# CERTIFICATE OF SURVEY

LEGAL:  
LOT 20, BLOCK 1, NORTHFORK ST. ANDREWS ADDITION  
ACCORDING TO THE RECORD PLAT THEREOF ON FILE  
IN THE OFFICE OF THE COUNTY RECORDER IN AND FOR  
ANOKA COUNTY, MINNESOTA

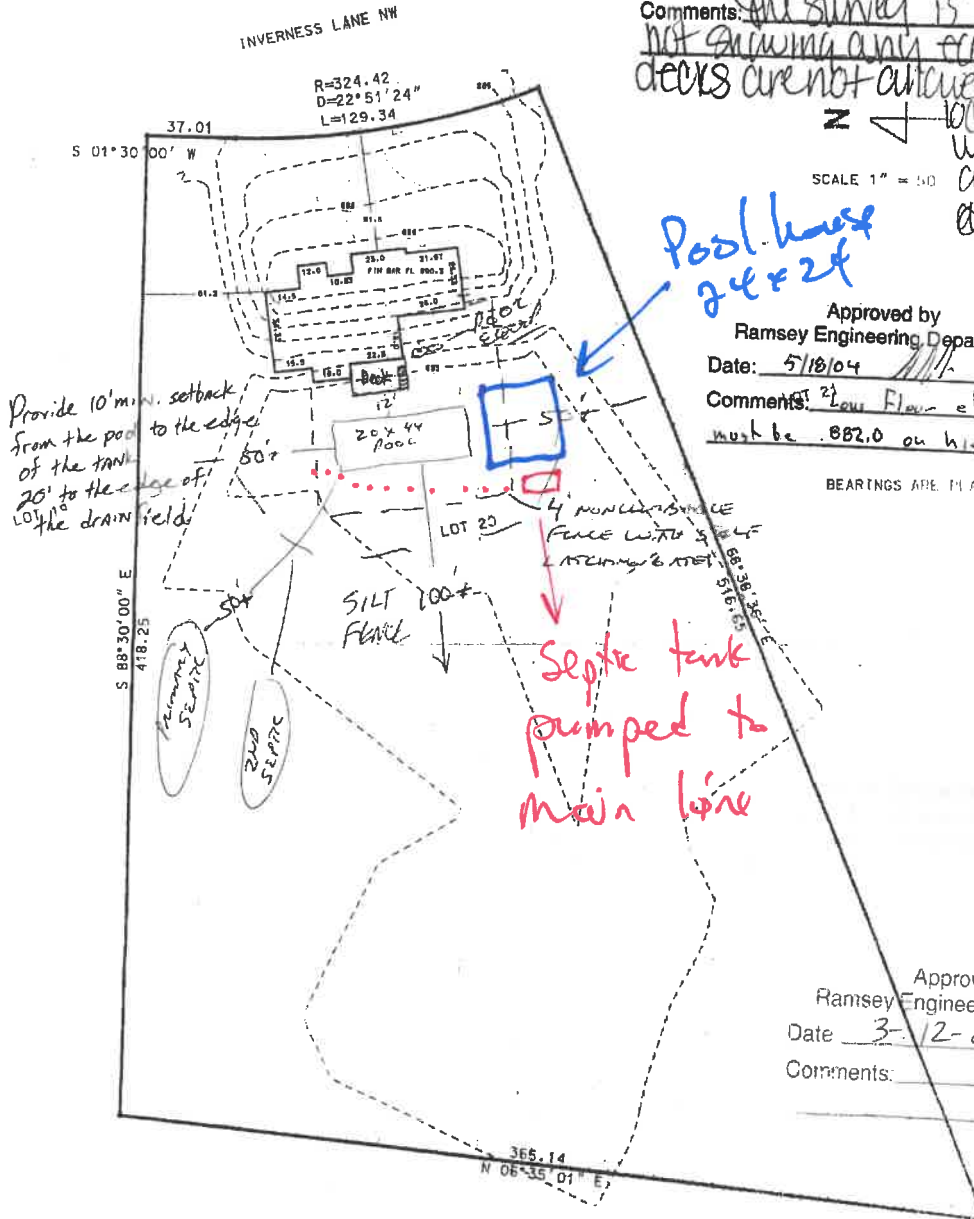
Comments: ALL SURVEY IS  
NOT SHOWING ANY EASEMENTS  
DECKS ARE NOT ANTICIPATED TO BE

located  
within  
a wetland  
OR easement

Comments: Low Floor elevation  
must be .882.0 or higher

Provide 10' min. setback  
from the pool to the edge  
of the tank  
20' to the edge of  
the drain field
